APPLICATION FOR CERTIFICATE OF APPROPRIATENESS HISTORIC CONSERVATION BOARD PUBLIC HEARING STAFF REPORT

APPLICATION #: COA2019025
APPLICANT: OTR Adopt
OWNER: OTR Adopt
ADDRESS: **2017 Colerain Ave**
PARCELS: 184-0005-0027
ZONING: RM 0.7/Historic District Overlay
OVERLAYS: Dayton Street Historic District
COMMUNITY: West End
REPORT DATE: May 31, 2019
PRE HEARING: May 29, 2019
STAFF REVIEW: Beth Johnson, Urban Conservator

The applicant is requesting a Certificate of Appropriateness (COA) to demolish a one story rear non-contributing frame addition that is not part of the original construction.

Figure 22017 Colerain Ave. The addition is outlined in red.

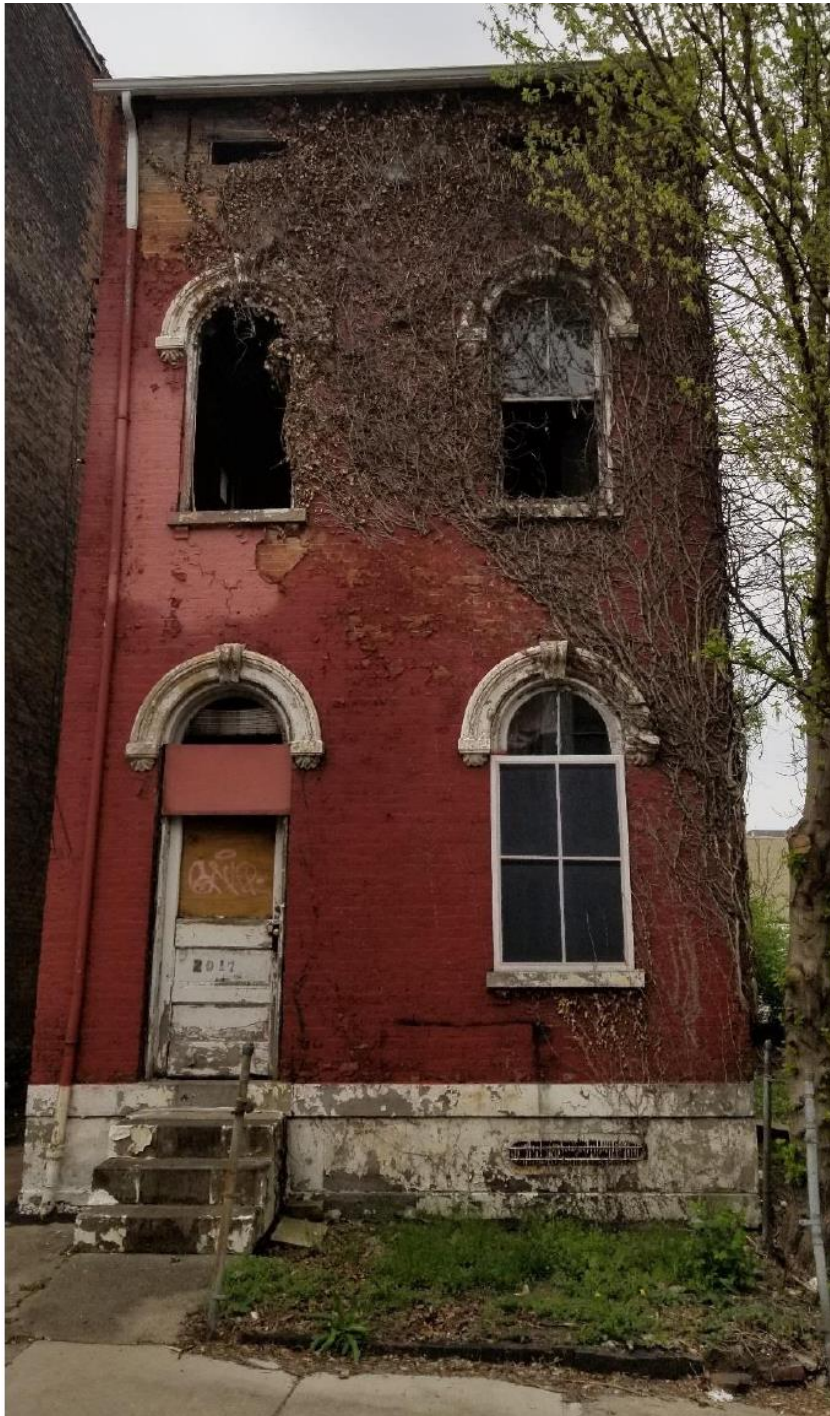
The proposed demolition is for a concrete block garage addition that is on the rear of property. The Dayton Street Historic District does not have any guidelines as it relates to the demolition of buildings or inappropriate additions. The only guidelines in regards to demolitions are for the allowance for demolition of non-contributing buildings if they do not adversely affect the character.

After reviewing the pictures (please see attached pictures) with the applicant and doing a site visit to the property, we believe that the addition is a noncontributing portion of the building that will not adversely affect the character of the Historic District. The principal contributing building will remain and will be rehabbed.

The addition was built between 1922 and 1950 (after the period of significance for the district) and has wood siding a CMU foundation and is of different construction compared to the historic building. While the guidelines only list non-contributing buildings and not-additions, staff is of the opinion the removal of this addition is compatible with the guidelines as the removal of the addition will not negatively impact the main historic building and will not adversely affect the streetscape. The addition is not visible from the street.

The addition is in a poor and deteriorating state with rotted siding, a portion of the south façade is missing and it is not entirely attached to the building. There are no outstanding code violations for this property and Demolition has not been ordered by the Director of Buildings and Inspections.

Figure 4: Alta Survey showing the sewer line running through the middle of the property. Map provided by applicant.

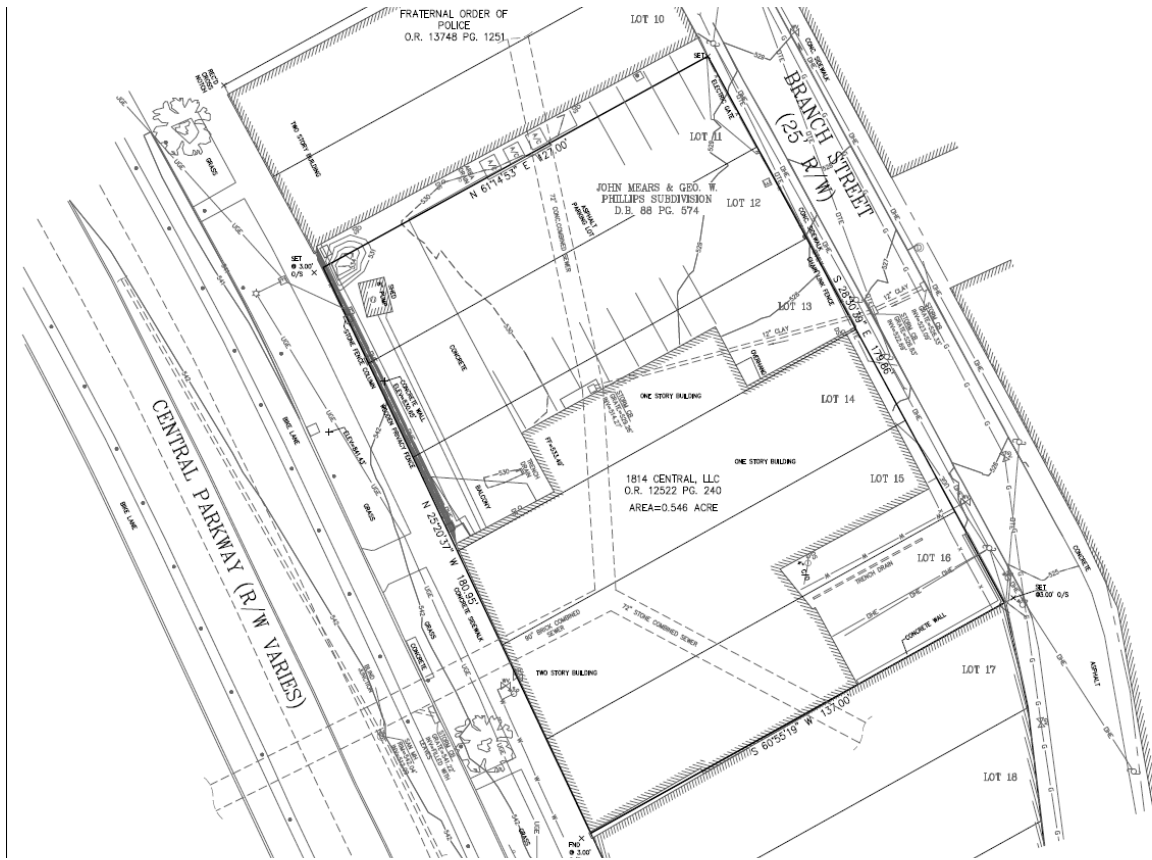
The first request concerns the size of the Outdoor Area. The property is located approximately 485 feet from an RMX zoning district, and the outdoor space is over 50% larger than the interior. The interior space open to the public is 4,900 sf. The exterior space is 9,971 sf, or 200+-% larger. The area is currently a paved area and underneath the paved area is a public sewer main with restrictive easements. The property owner is restricted to building at either the very front or very rear of the property. This makes a larger building impractical and the use of the majority of the lot as an open space is the most practical and economical use for the space.

Figure 5: Map showing the property and its location to an RMX facility.

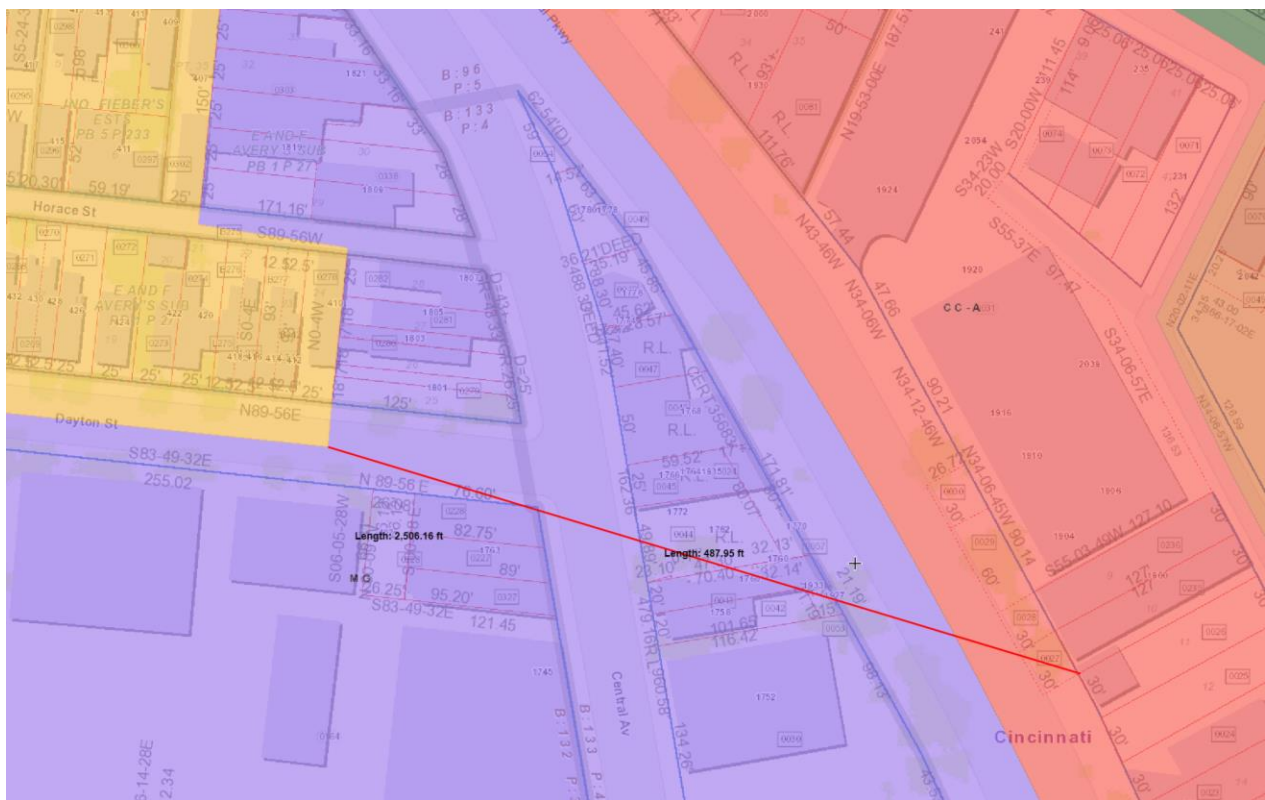
a project with live music may generate sound levels of 100-120 decibels, lack of understanding of the potential situation and having base line date pre- and post-Outdoor Entertainment makes it difficult to assure neighbors that the proposed sound levels will be compliant or will potentially create, an adverse effect.

Staff initially requested a sound study on 5.21.19 after an initial review of the submission and again reiterated that we could not recommend approval at the prehearing on 5.29.19 without a sound study evidence demonstrating the compliance could be achieved as proposed. Staff has not received a sound study, but the applicant has suggested via email that they would like to request an approval with a condition that the Outdoor Entertainment shall not be permitted unless a sound study is performed once the venue is built and additional sound proofing mechanisms are added and the sound study shows the Noise Ordinance would not be violated.

Figure 5: Alta Survey with the 1 story addition that is proposed for demolition.

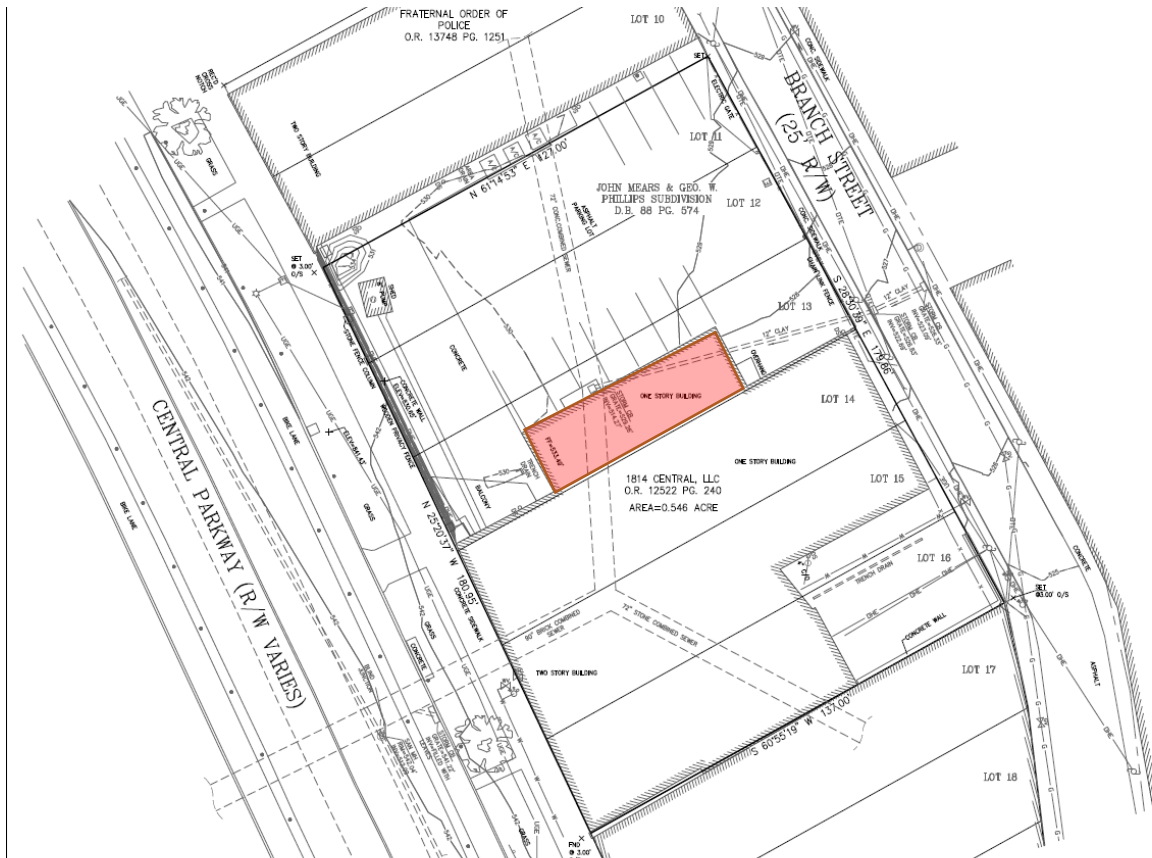
The project is requesting the demolition of a portion of the existing structure that is on the interior of the lot. This section of the building is a non-original addition and does not contribute to the streetscape. Staff is supportive of the demolition request.

Figure 7: Henry/Branch Street view. Image provided by Google Street Views.

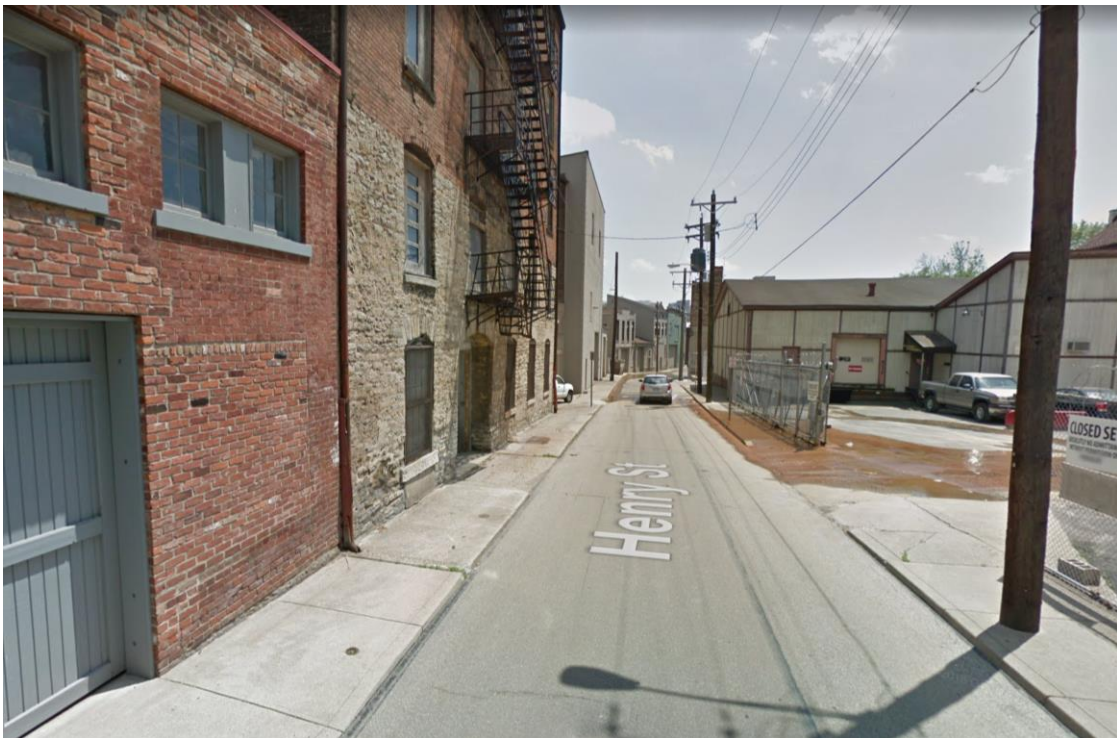
On the interior of the property a new façade treatment with large glass paneled garage doors on the façade facing into the courtyard are new openings in a formally covered wall. As this is a warehousing type building, large garage door style openings are appropriate. These will be visible from Henry/Branch Street; however, this street is only 18 feet wide and acts as an alley way as most of the buildings on the street have their rear frontages and loading areas along this street. Garage doors are a common form along alleys and in particular here.
